## EIA analysis of nuclear power project by Nuclear Power Corporation of India limited

### Background of the technical report

Nuclear Power Corporation of India Limited (NPCIL) is planning to set up a 6,000 MWe nuclear power plant in Bhavnagar district of Gujarat. On behalf of the local community there, an NGO called Paryavaran Mitra requested the Centre for Science and Environment to technically evaluate the Environment Impact Assessment (EIA) report of the project.

**Picture 1: Leaks in AP1000**

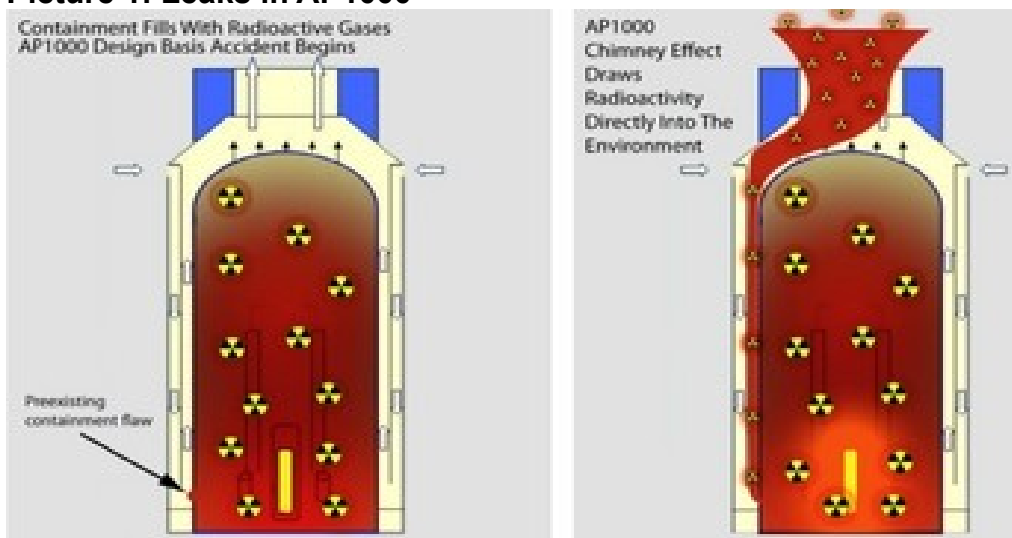
**CSE's Comment:** Advance Passive reactor plant is called Westinghouse's AP 1000.<sup>12</sup> Originally the reactor was approved in the year 2005 in U.S.<sup>13</sup> after which the company resubmitted its modified design in 2007 but faced a hard time for its approval.<sup>14</sup> After 19 revisions of the design the company got its approval in December 2011.<sup>15</sup> The fear described was if there happens to be a leak on the side of the nuclear reactor wall owing to extreme events like earthquake, hurricane, etc., then the radiations would escape out of

the chimney of the nuclear reactor. (see *Picture 1: Leaks in AP1000*).

Such a concern and the impact of the situation has not been discussed in the EIA report. It is imperative to reassess this aspect especially with the controversy in America. Besides there are studies which say nuclear radiation on high doses causes weakening in concrete<sup>16</sup> and steel structures.<sup>17</sup> But there are no discussions on the possible high dose emission from the nuclear reactor and the measures taken to curb such emissions.

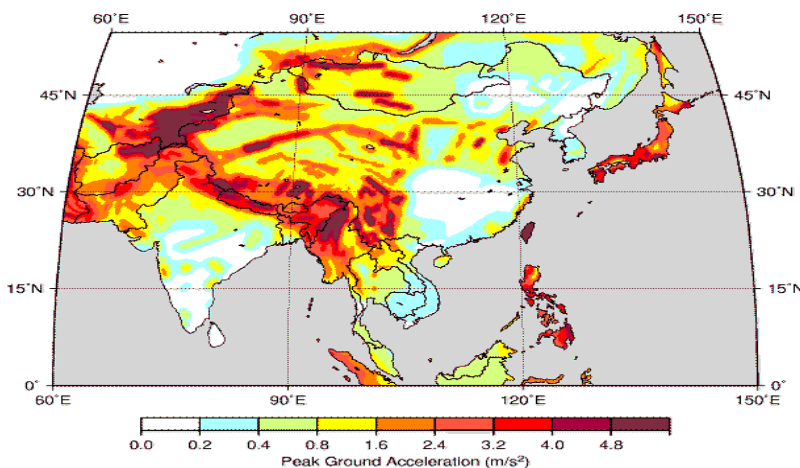
**CSE's Comment:** But a global seismic hazard program of Eastern Asia shows that Fukushima and Bhavnagar area lies in the same risk zone.

**Figure 1: Action flow diagram for site/ Off site emergencies<sup>55</sup>**

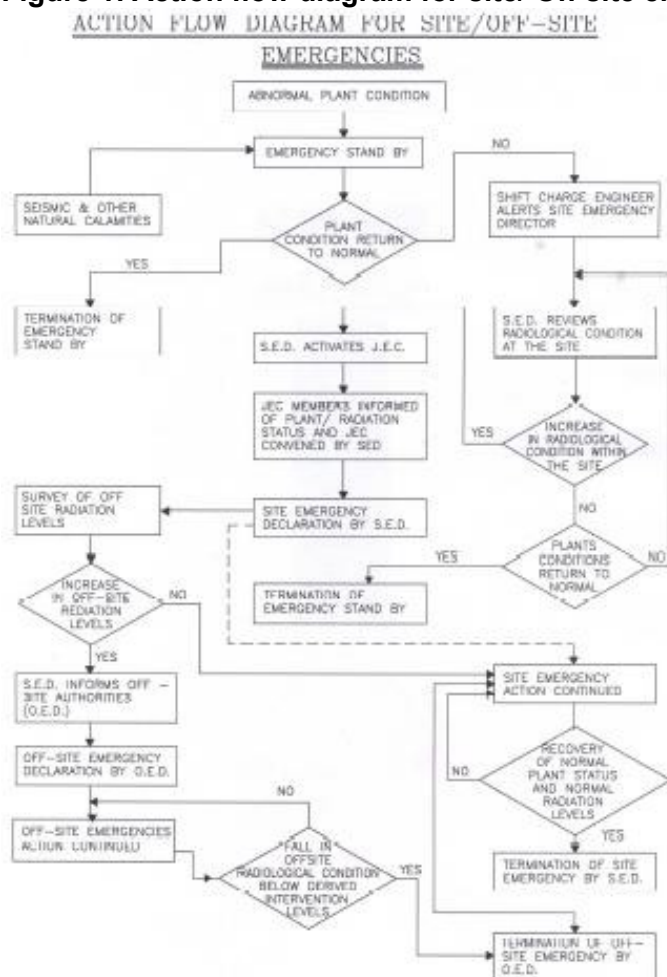
**CSE COMMENT:** The agencies responsible for onsite/offsite emergencies are discussed in the EIA report as below,<sup>56</sup>

Thus NPCIL takes no charge of providing a mitigation measure to the affected community in case of an off-site emergency. Also no details of what would happen, how it will be dealt with and who will be in charge of dealing with it in case of on-site emergencies is not clear.
